## REMARKS

## DRAWING AMENDMENTS

Fig 1

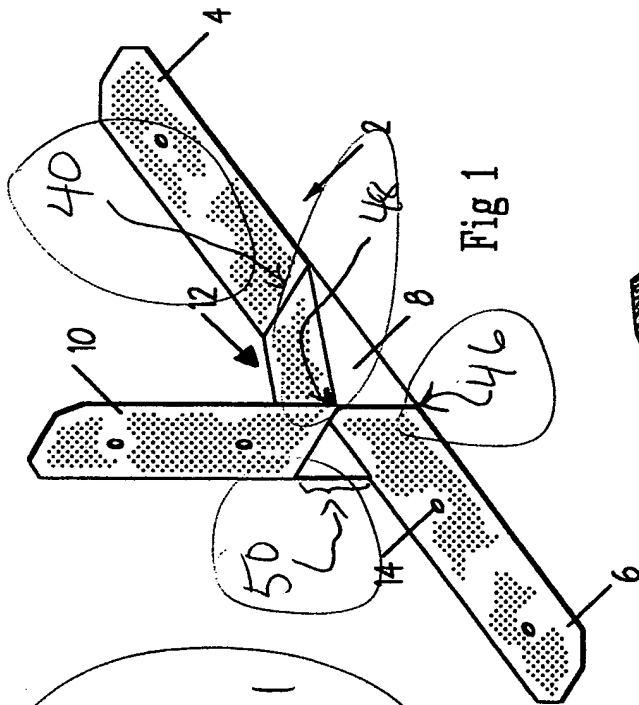
#1's  
 50,401  
 46 + 48  
 were  
 added  
 to  
 Fig. 1

Fig 3

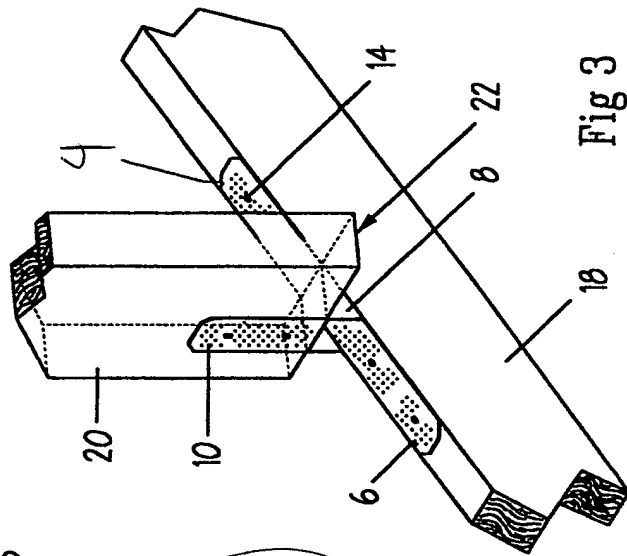
the #4  
 was  
 added  
 to  
 Fig. 3

Fig 4

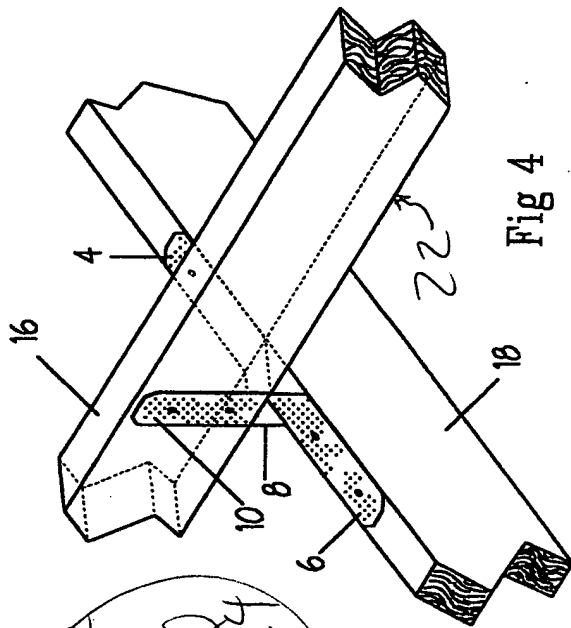
the #22  
 was  
 added  
 to  
 Fig. 4

Fig 5

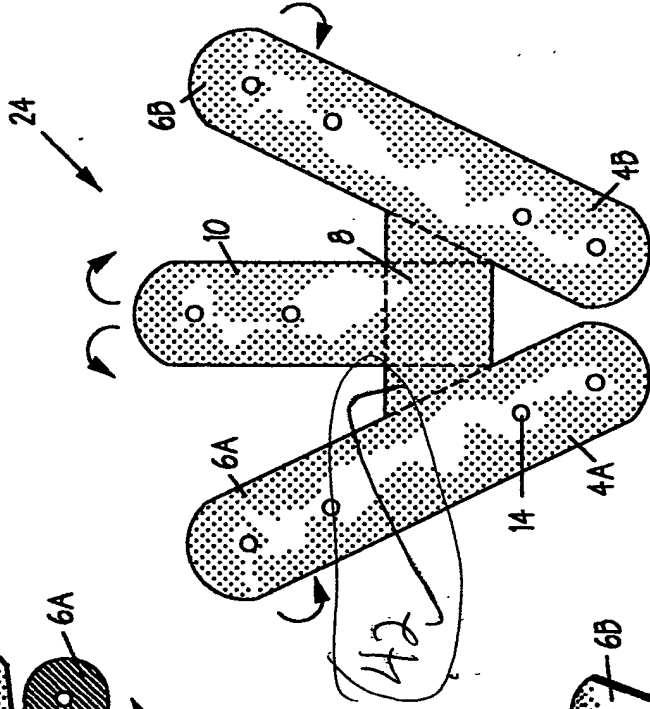
#42 was added to Fig. 5

Fig 15

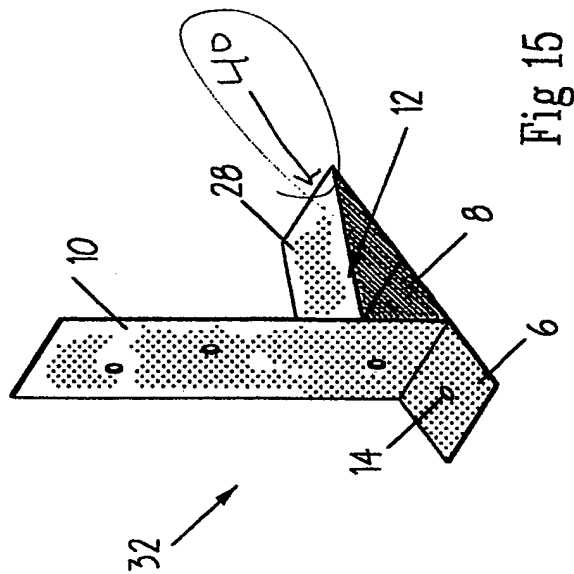
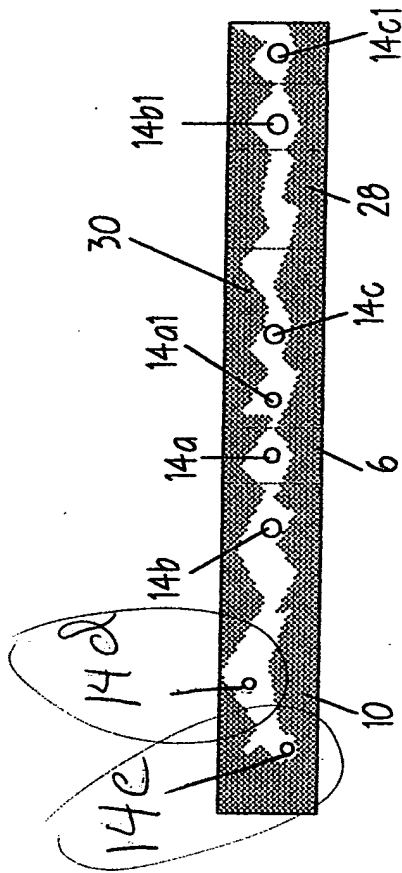
The #'s 40 14e  
 + 14d were added to Figs 15 + 16

Fig 17

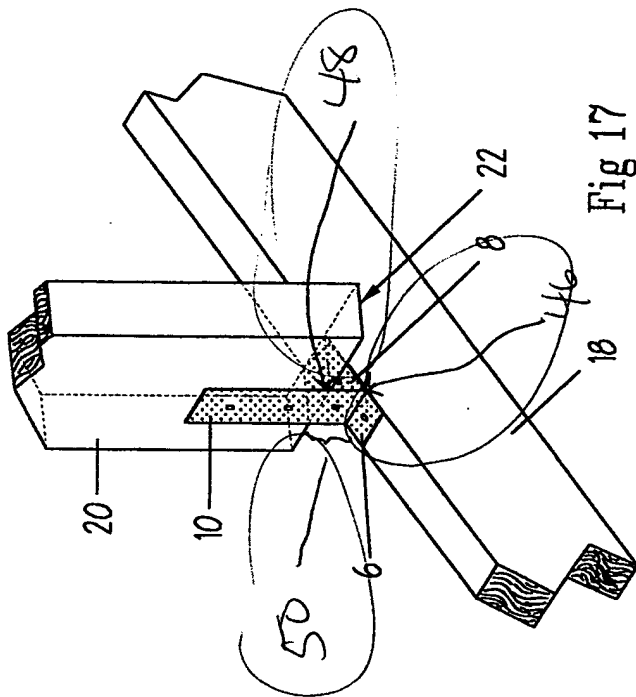
Also the  
 #'s 50, 48  
 + 46 were  
 added  
 to Fig. 17

Fig 19

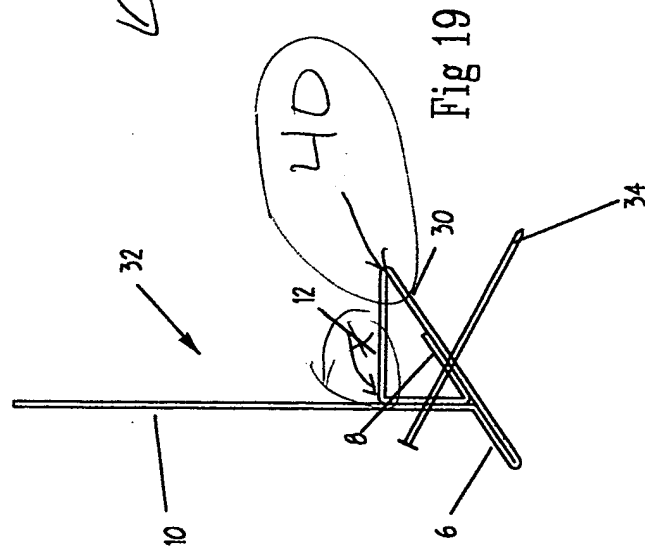
The arrow extending  
 was reangled  
 for accuracy  
 + the # 48  
 was added  
 to Fig 19

Fig 21

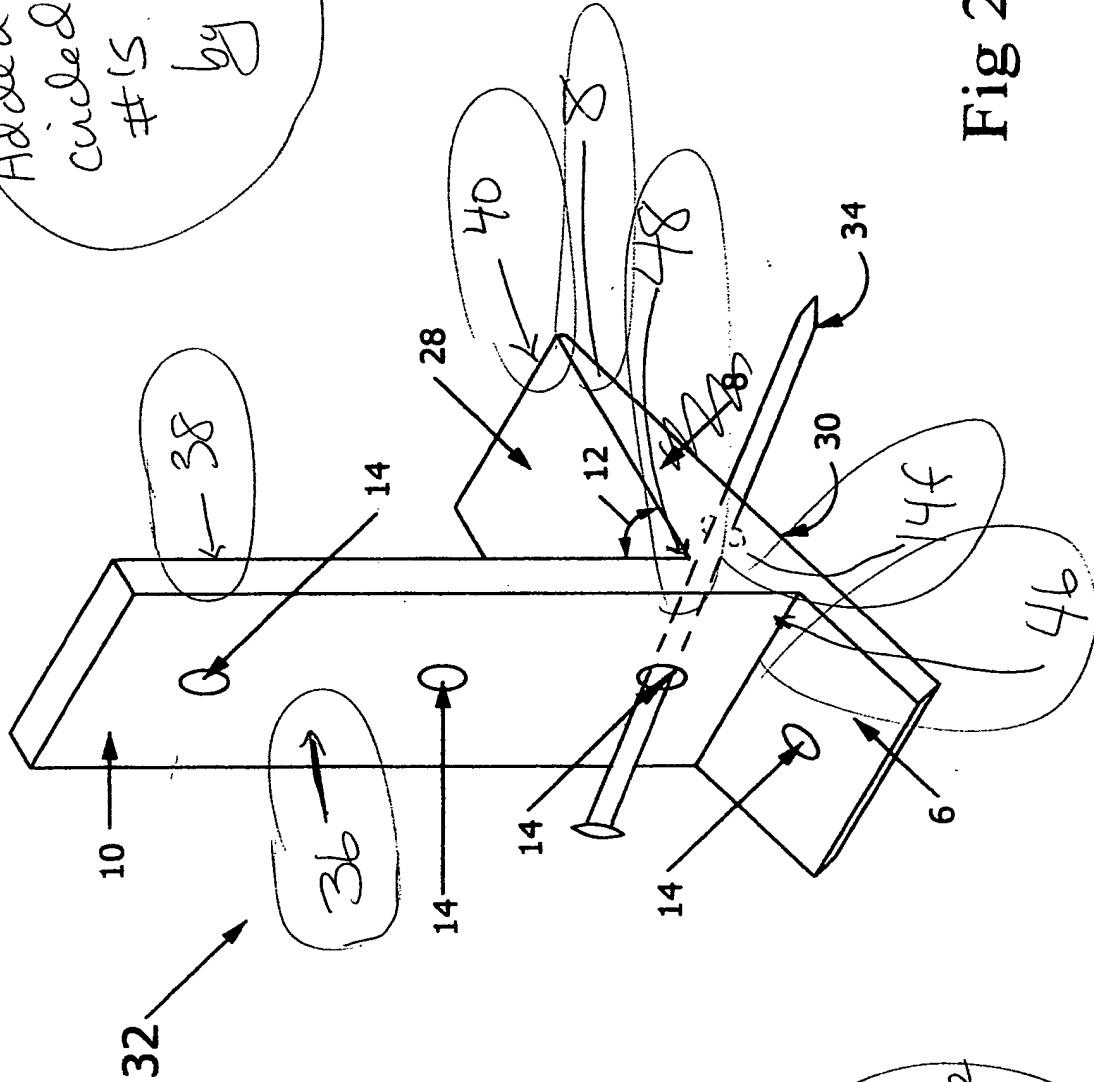
Annotated Sheets showing the changes made with hand-written notes and Replacement Sheets are being provided herein, which each showing additional numbers to identify the currently existing features cited by the Examiner as needing clarification, to include 'opposing sides' of the web member (now 36 and 38 in Fig. 21), 'lower end' (now 46 and 48 in Figs. 1 and 21), 'base member' (6, as shown in Fig. 1), 'top surface' (28, as shown in Fig. 21), 'roof pitch angle' (44, as shown in Fig. 20), 'topmost fastener hole' (14e, as shown in Fig. 16), 'bottommost fastener hole' (14b, as shown in Fig. 16), 'additional fastener hole' (now wedge hole 14f in Fig.

21), the 'fastener hole that is closest to the base member' (now identified as 'bottommost hole' 14b), the 'remaining fastener holes' (now identified as 'intermediate hole(s)' 14d), 'taller end' (50, as shown in Figs. 1 and 17), and the 'bottommost portion of the web member' (this term is not being added to the drawings as it was not found in the currently pending claims and is believed to have been removed when claim 15 was previously withdrawn.) Seven drawings sheets are currently a part of the instant patent application, and six Replacement and six Annotated sheets are being made a part of this response, with the only drawing sheet not being amended being the one displaying Figs. 10-12. The additional numbering used in the drawings is now also being added through amendment to the specification herein. The applicants now believe that all of the features of the invention in the claims are shown in the drawings. Therefore, the applicants respectfully request that the Examiner withdraw her rejection of the drawings.
